Subject: Fuel Leak Case No. RO0002894 and Geotracker Global ID T06019716197, Springtown Gas, 909 Bluebell Drive, Livermore, CA 94551

**TECHNICAL COMMENTS**

Subject: Fuel Leak Case No. RO0002894 and Geotracker Global ID T06019716197, Springtown Gas, 909 Bluebell Drive, Livermore, CA 94551 – Work Plan Approval

Subject: Fuel Leak Case No. RO0002894, Springtown Gas, 909 Bluebell Drive, Livermore, CA –  
Work Plan Review

BSK Job No. 040-40-0072  
 GROUNDWATER ELEVATION  
 CONTOUR MAP  
 FIGURE 10

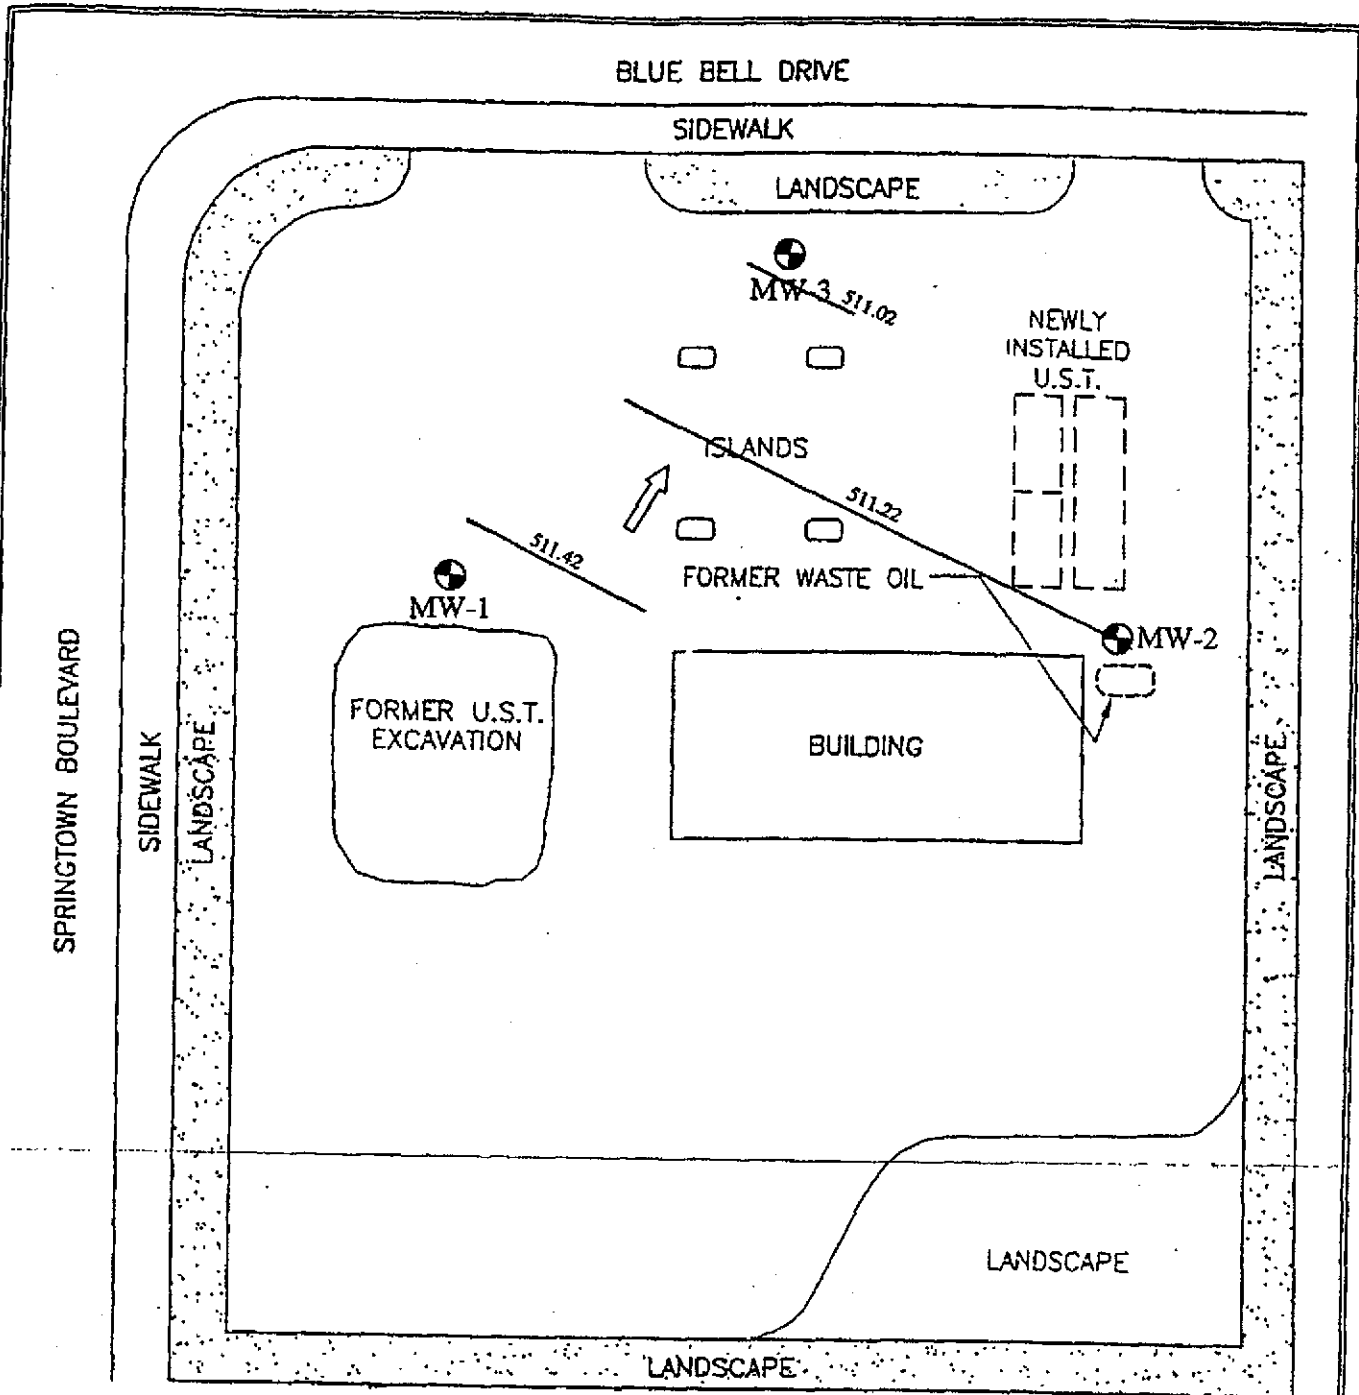
Attachment: Groundwater Elevation Contour Map by BSK & Associates

← Revised Figure 2

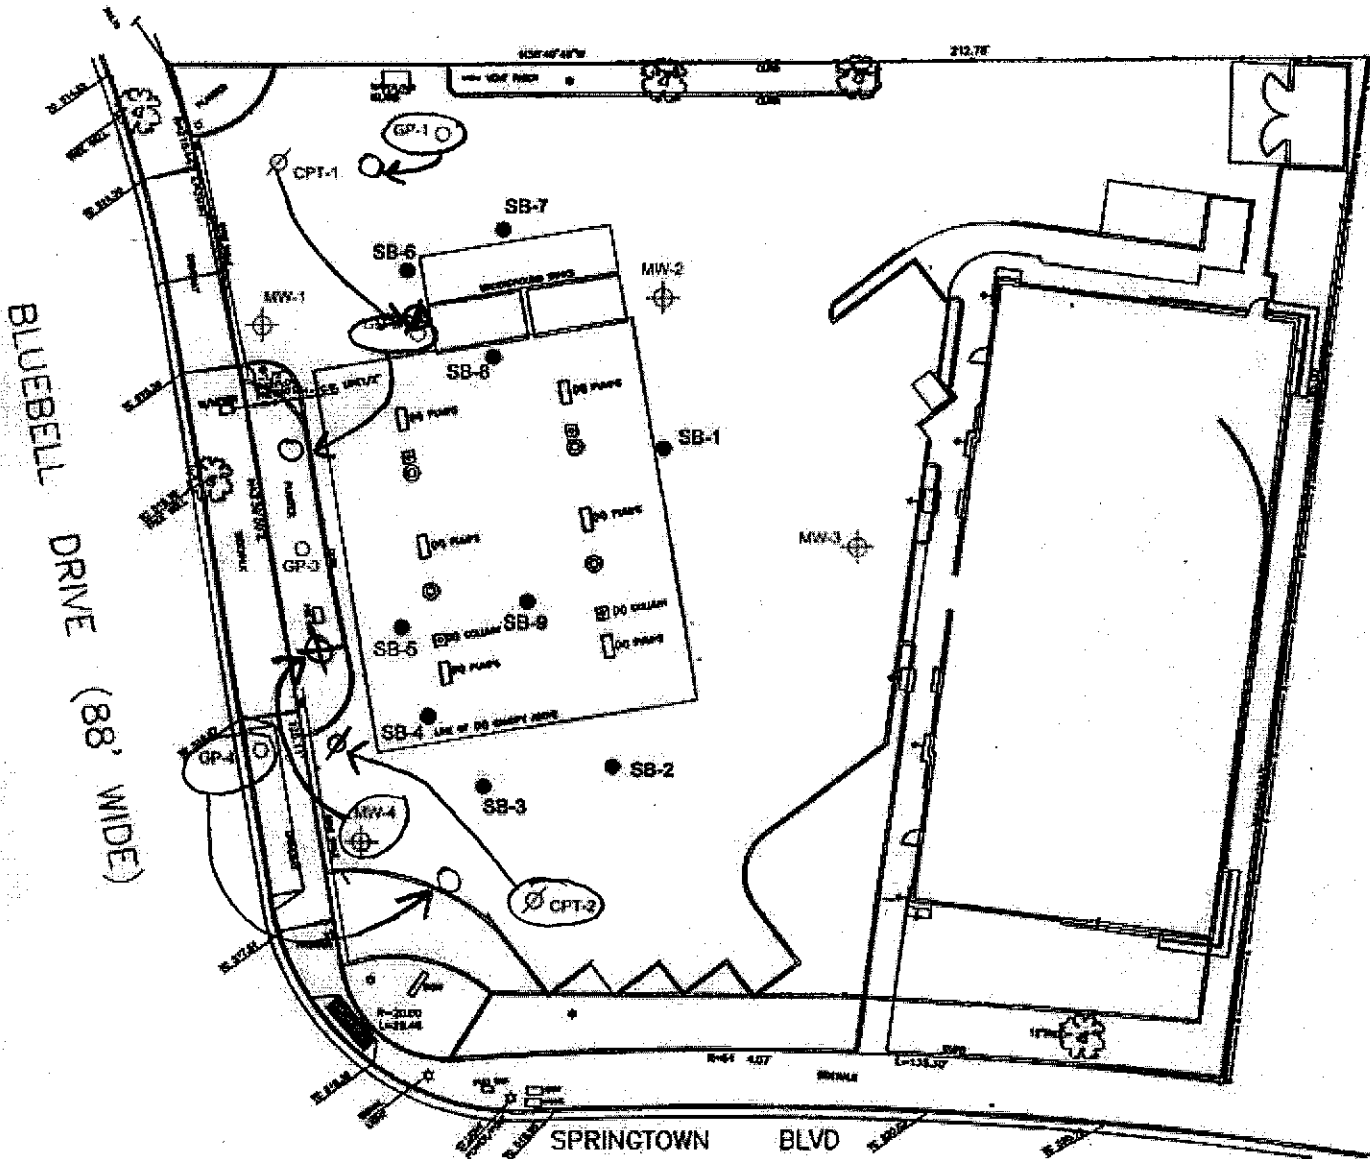
1. **Revised Boring Locations.** We request that the proposed boring and monitoring well locations be revised as shown on Revised Figure 2. Please present results from the site investigation in the Soil and Groundwater Assessment Report requested below.

Revised Figure 3

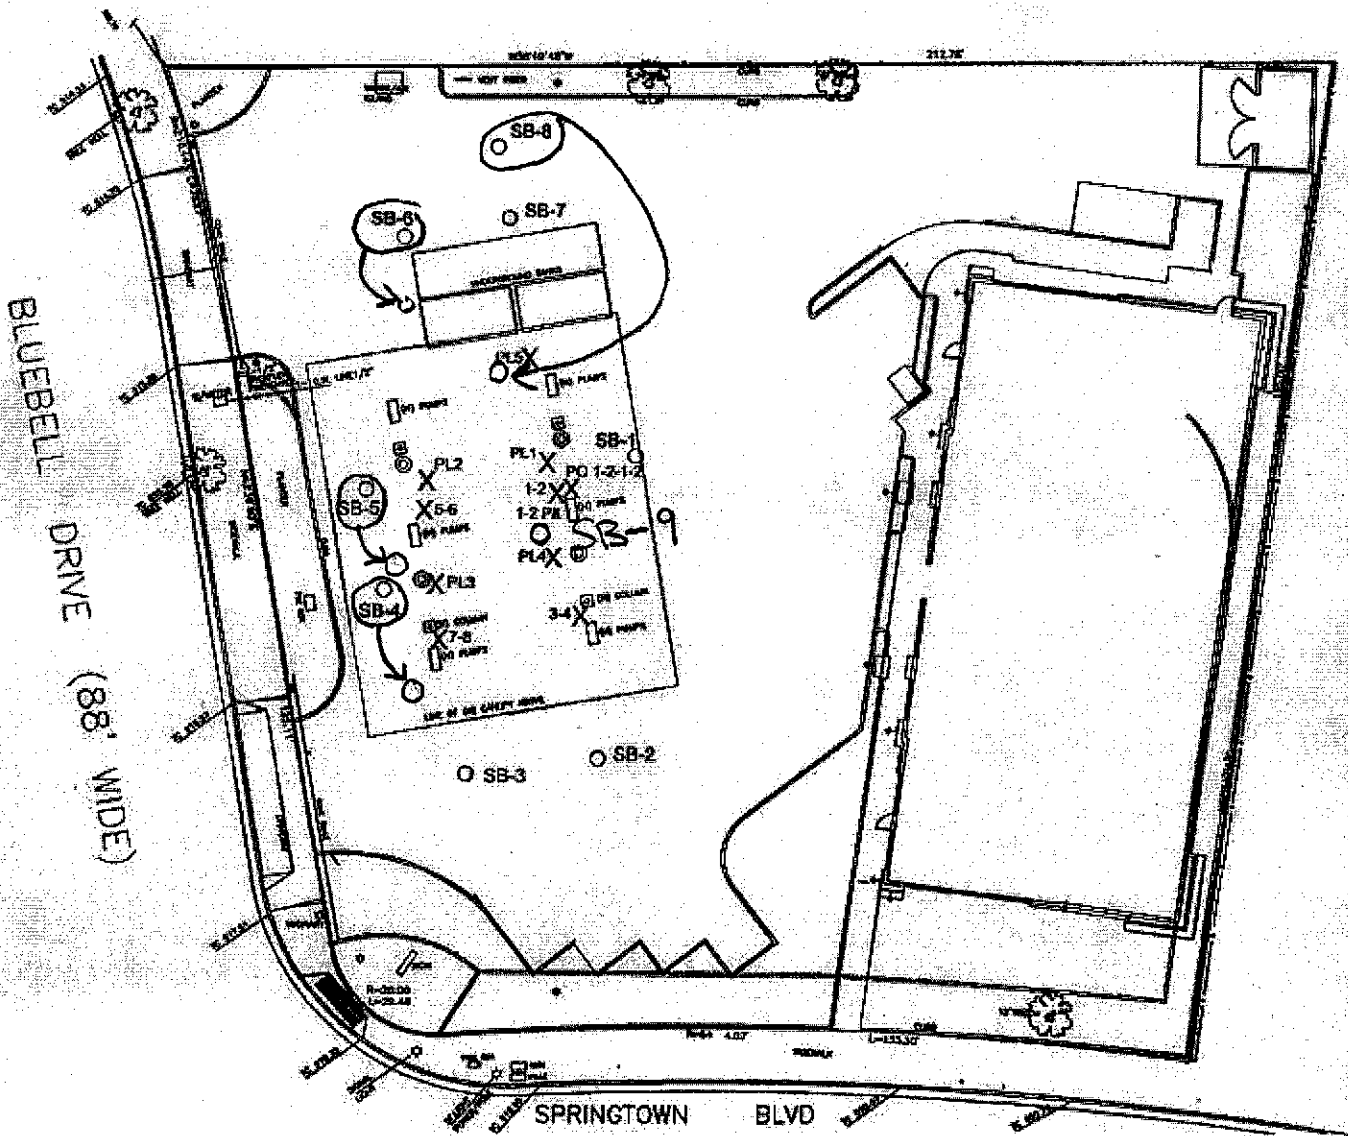
- 1. Quality of Figures in Report.** Two of the three figures in the Work Plan are of poor quality making them difficult to use. The text on Figure 1 appears blurred and is generally indecipherable. Figure 2 has no scale or points of reference, making the figure largely unusable. Figure 3 is of acceptable quality. Please assure that the figures in future reports are of similar or better quality to Figure 3 rather than Figures 1 or 2.

- 3. Proposed Boring Locations.** The proposed boring locations are generally located around the perimeter of the dispensers and USTs. We request that four of the soil borings (SB-4, SB-5, SB-6, and SB-8) be moved to locations closer to the likely sources of contamination as shown on the Revised Figure 3, which is included as an attachment to this correspondence. We also request that one additional soil boring (SB-9) be advanced within the dispenser area where significant contamination was previously observed during the dispenser upgrade. All soil boring locations must be cleared for subsurface obstructions to assure that utilities and product piping are not damaged by the soil borings as discussed in the Health and Safety Plan. If utilities or other subsurface obstructions are present at any of the proposed locations, please move the locations to the nearest location where the boring can be safely advanced. Please present results from the soil borings in the Site Investigation Report requested below.
